**Model
Administrative Change Notice**

1. Document Number:	MDL-NBS-HS-000006	2. Revision:	03/ND01	3. ACN:	01
4. Title:	UZ Flow Models and Submodels				
5. No. of Pages Attached	86 91	87	87-7-08

4. Title: UZ Flow Models and Submodels

Figure 6.4-1. Comparison of Simulated (solid line) and Observed (solid dots) Gas Pressures at Borehole UZ-7a during the First 30-Day Period

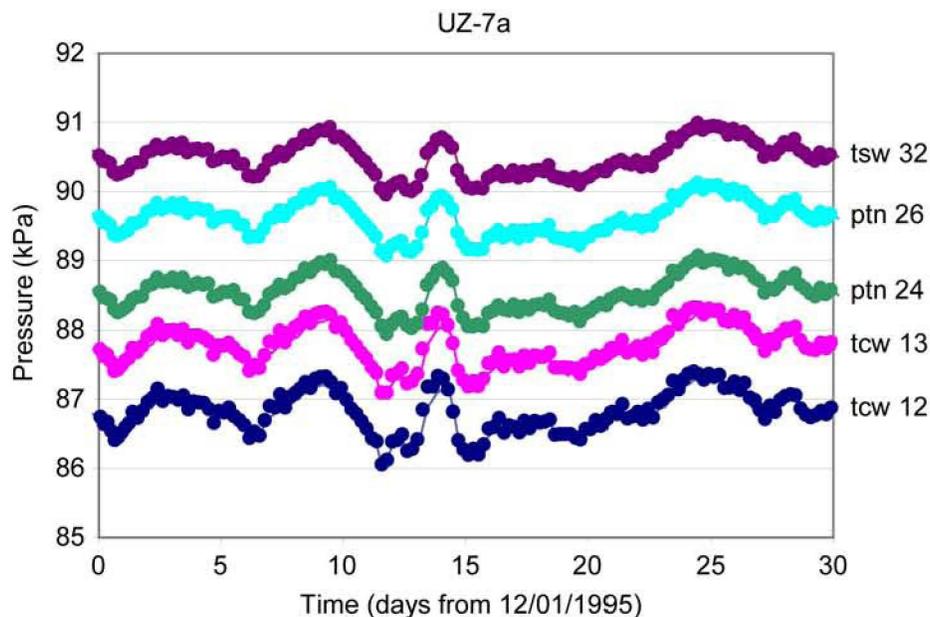
- 6-59 Figure 6.4-1: Replaced figure to correct the UZ model grid unit labeling on the curves (e.g., “tcw 12”, “tsw 32”, etc.) and to change the units on the y-axis label from “KPa” to “kPa”.
Figure 6.4-1, NOTE: Added “The hydrogeologic units shown on the figure (e.g., tcw12) are determined from a comparison of the borehole location and measurement depth with the spatial data for the hydrogeologic units available from the UZ model grid.”

Figure 6.4-2. Comparison of Simulated (solid line) and Observed (solid dots) Gas Pressures at Borehole SD-12 during the First 30-Day Period

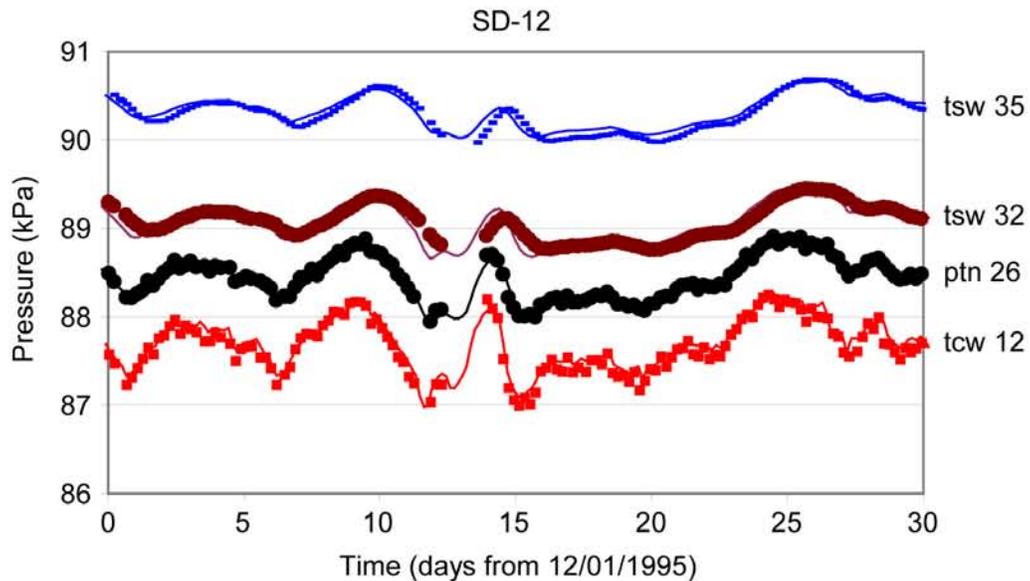
- 6-60 Figure 6.4-2: Replaced figure to correct the UZ model grid unit labeling on the curves (e.g., “tcw 12”, “tsw 35”, etc.) and to change the units on the y-axis label from “KPa” to “kPa”.
Figure 6.4-2, NOTE: Added “The hydrogeologic units shown on the figure (e.g., tcw12) are determined from a comparison of the borehole location and measurement depth with the spatial data for the hydrogeologic units available from the UZ model grid.”

Figure 6.4-3. Comparison of Simulated (solid line) and Observed (solid dots) Gas Pressures at Borehole UZ-7a during the First 30-day Period

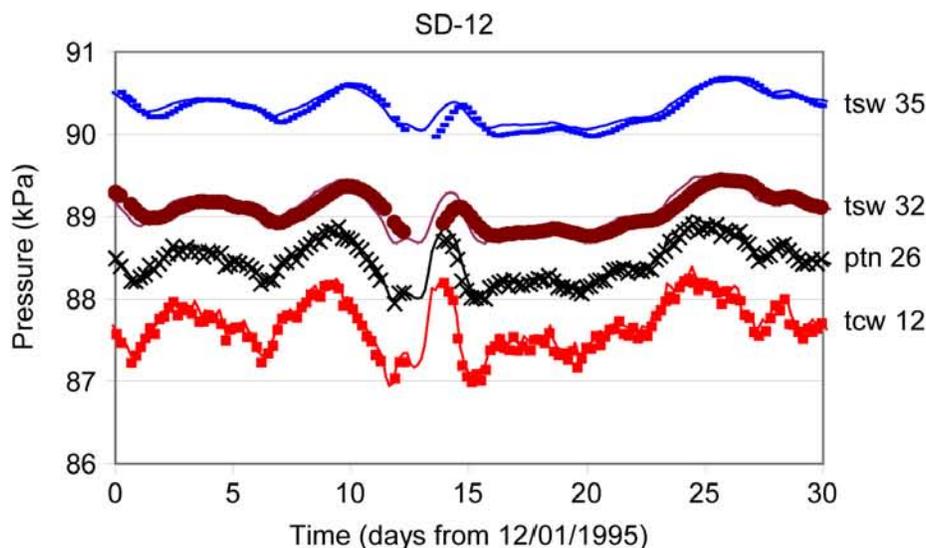
- 6-62 Figure 6.4-3: Replaced figure to correct the UZ model grid unit labeling on the curves (e.g., “tcw 12”, “tsw 32”, etc.) and to change the units on the y-axis label from “KPa” to “kPa”. Also changed “UZ-71” to “UZ-7a” in figure caption.
Figure 6.4-3, NOTE: Added “The hydrogeologic units shown on the figure (e.g., tcw12) are determined from a comparison of the borehole location and measurement depth with the spatial data for the hydrogeologic units available from the UZ model grid.”

Figure 6.6-2. Simulated Percolation Fluxes at the Repository Horizon under the Monsoon, 10th Percentile Infiltration Scenario

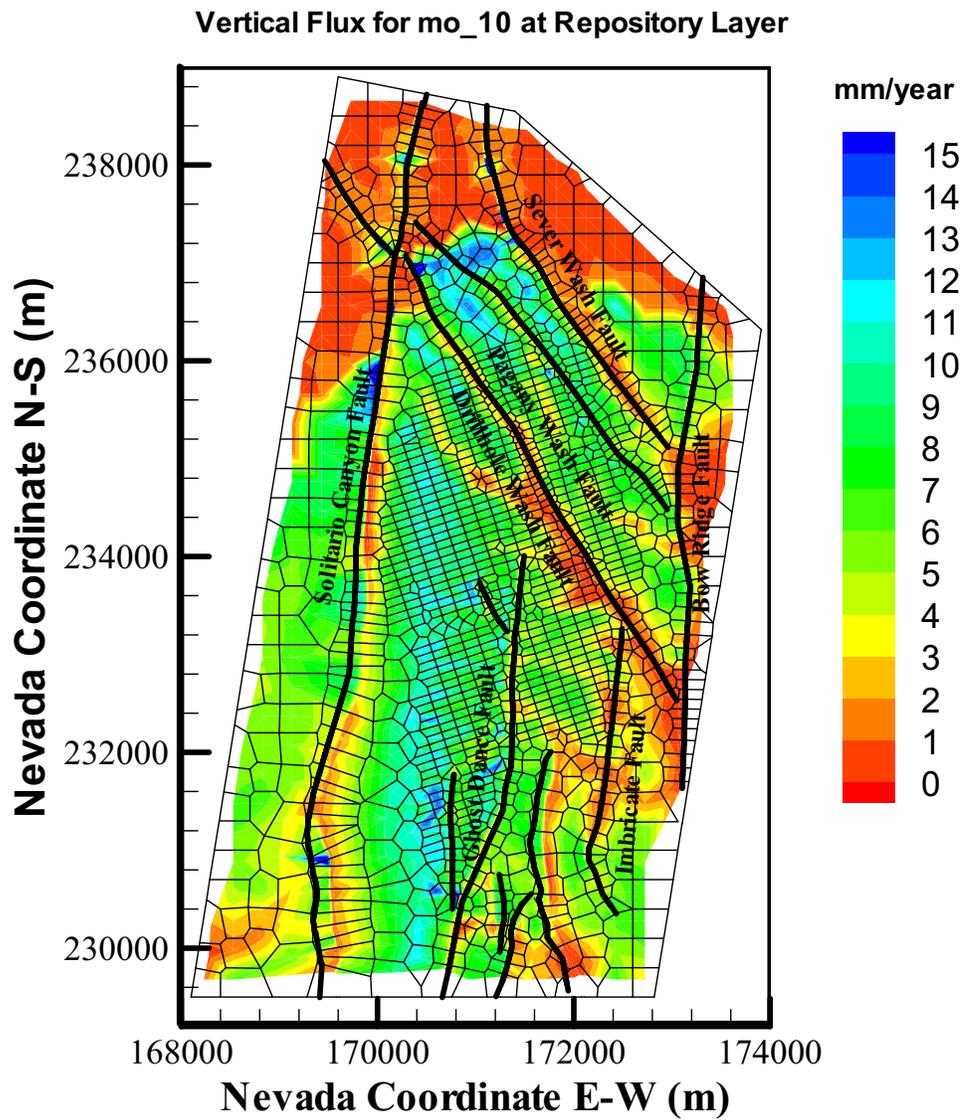
- 6-83 Figure 6.6-2: Removed superscripting from “th” in “10th” in caption. Figure caption now reads:
“Simulated Percolation Fluxes at the Repository Horizon under the Monsoon, 10th Percentile Infiltration Scenario”.

Figure 6.8-2. Posterior Weighting Factors for Infiltration Map

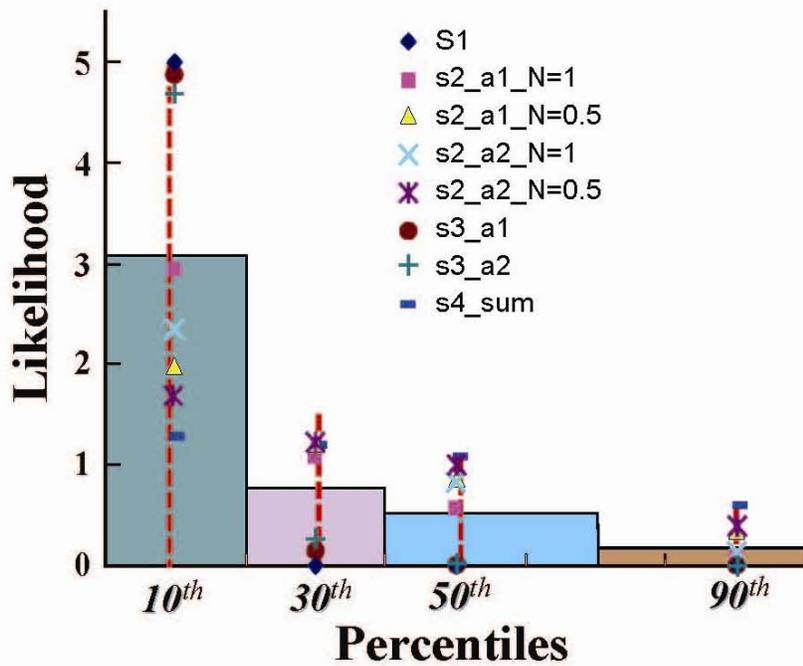
- 6-118 Figure 6.8-2: Replaced figure to make the plotting symbols visible in the shaded portions of the figure.
Figure 6.8-2, NOTE: Placed figure note on separate line from DTN listing.

Figure 7.4-1. Comparison of Predicted (solid line) and Observed (solid dots) Gas Pressures at Borehole UZ-7a During the Second 30-day Period for the 10th Percentile Infiltration Scenario

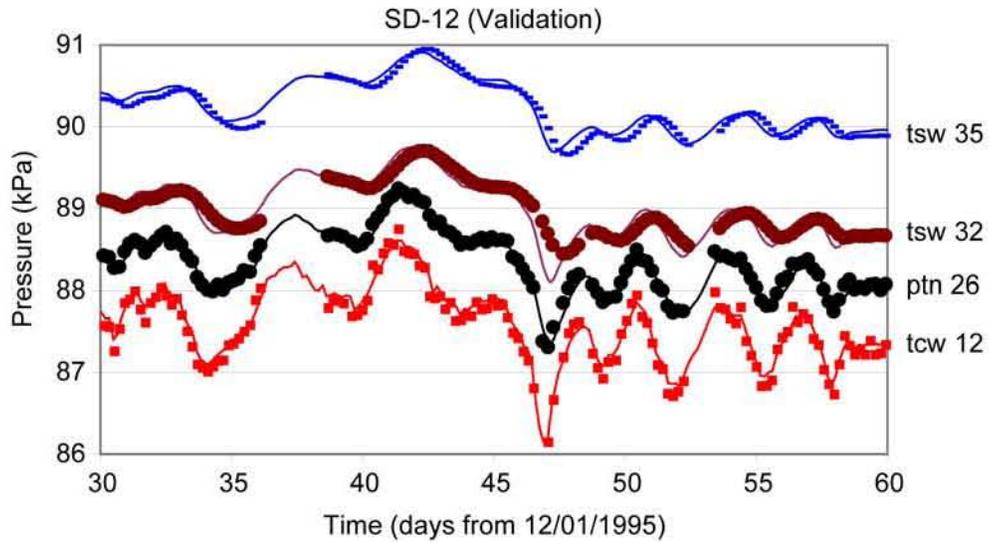
- 7-4 Second paragraph, last sentence: Replaced “model is” with “model’s”.
- 7-9 Heading for Section 7.4.1: Added a “th” after “10”. Heading now reads: “Validation of the UZ Model for the Scenario of the 10th-Percentile Infiltration Map”.
Figure 7.4-1: Replaced figure to correct the UZ model grid unit labeling on the curves (e.g., “tcw 12”, “tsw 32”, etc.) and to change the units on the y-axis label from “KPa” to “kPa”.
Figure 7.4-1, NOTE: Added “The hydrogeologic units shown on the figure (e.g., tcw12) are determined from a comparison of the borehole location and measurement depth with the spatial data for the hydrogeologic units available from the UZ model grid.”

Figure 7.4-2. Comparison of Predicted (solid line) and Observed (solid dots) Gas Pressures at Borehole SD-12 During the Second 30-day Period for the 10th Percentile Infiltration Scenario

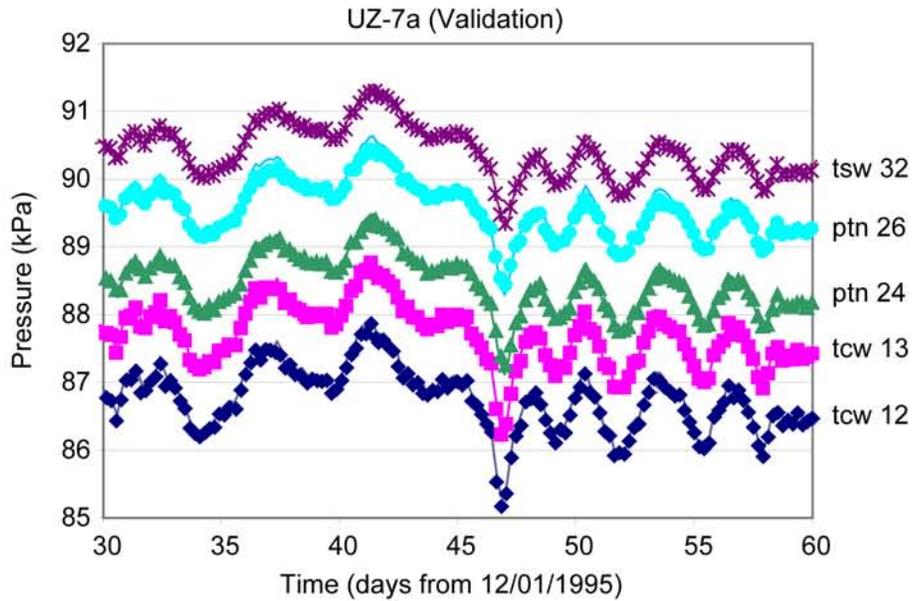
- 7-10 Figure 7.4-2: Replaced figure to correct the UZ model grid unit labeling on the curves (e.g., “tcw 12”, “tsw 35”, etc.) and to change the units on the y-axis label from “KPa” to “kPa”.
Figure 7.4-2, NOTE: Added “The hydrogeologic units shown on the figure (e.g., tcw12) are determined from a comparison of the borehole location and measurement depth with the spatial data for the hydrogeologic units available from the UZ model grid.”

Figure 7.4-3. Comparison of Predicted (solid line) and Observed (solid dots or symbols) Gas Pressures at Borehole UZ-7a During the Second 30-day Period for the 30th Percentile Infiltration Scenario

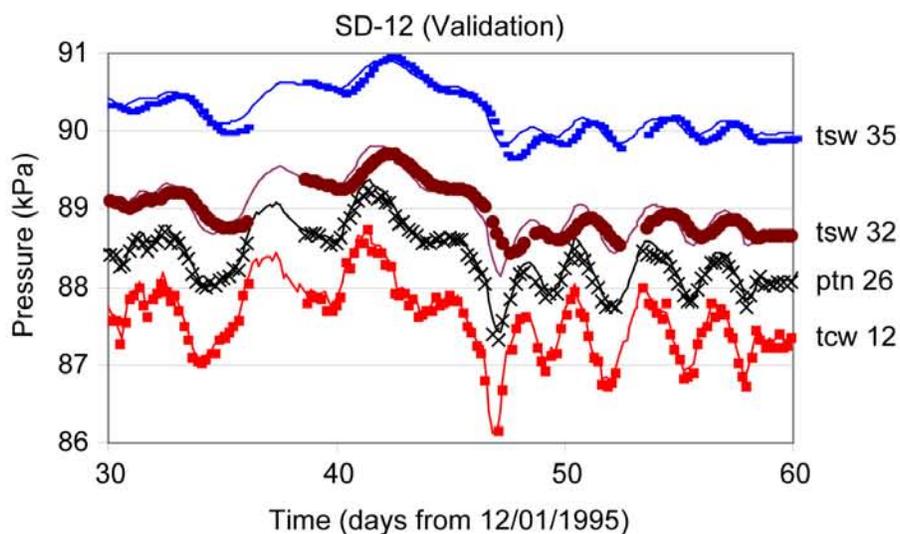
- 7-11 Figure 7.4-3: Replaced figure to correct the UZ model grid unit labeling on the curves (e.g., “tcw 12”, “tsw 32”, etc.) and to change the units on the y-axis label from “KPa” to “kPa”.
Figure 7.4-3, NOTE: Added “The hydrogeologic units shown on the figure (e.g., tcw12) are determined from a comparison of the borehole location and measurement depth with the spatial data for the hydrogeologic units available from the UZ model grid.”
